Access Compliance Report

Public Rights-of-Way (Curb Ramps)

Intersection ID: 31756	Main Street: FIRST_RUN_CT	Cross Street: PAPER_BIRCH_DR	Location: SW
ADA ID: F886ABF6D6D8	Ramp Type: Perp	Initial Pass/Fail: Fail	Overall Compliance: No
		Severity Score: 8.75

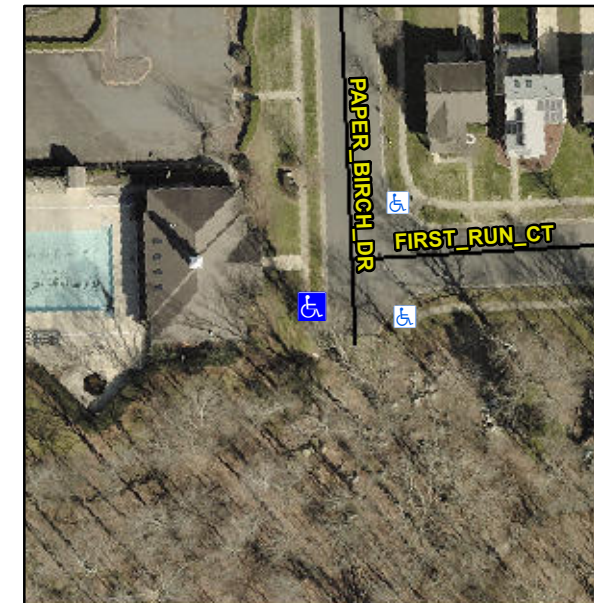
Not Found, R304.5.1

Compliance	Description	Data	Compliance	Description	Data
N/A	Ramp Length (in)	81.5	Yes	Ramp Slope (%)	5.3
No	Ramp Width (in)	47.0	Yes	Ramp XSlope (%)	0.9
N/A	Flare Type LT	N/A	N/A	Flare Type RT	N/A
N/A	Flare Slope LT (%)	N/A	N/A	Flare Slope RT (%)	N/A
N/A	Flare Traversable LT?	N/A	N/A	Flare Traversable RT?	N/A
N/A	Landing Length (in)	N/A	N/A	DWS Provided?	N/A
N/A	Landing Width (in)	N/A	N/A	DWS Contrast?	N/A
N/A	Landing Slope (%)	N/A	N/A	DWS Length (in)	N/A
N/A	Landing X Slope (%)	N/A	N/A	DWS Full Width?	N/A
N/A	Landing Curb? (Y/N)	N/A	N/A	DWS Offset (in)	N/A
N/A	Shared Landing?	N/A			
N/A	Gutter Ponding?	N/A	N/A	Gutter Slope (%)	N/A
N/A	Gutter Lip Ht (in)	N/A	N/A	Gutter X Slope (%)	N/A
N/A	Painted X Walk1?	No	N/A	Painted X Walk2?	N/A
	X Walk 1 Direction	To E		X Walk 2 Direction	N/A
N/A	X Walk 1 Width (in)	N/A	N/A	X Walk 2 Width (in)	N/A
	X Walk 1 Slope (%)	5.7		X Walk 2 Slope (%)	N/A
	X Walk 1 X Slope (%)	1.7		X Walk 2 X Slope (%)	N/A

Remove & Replace Entire Ramp.
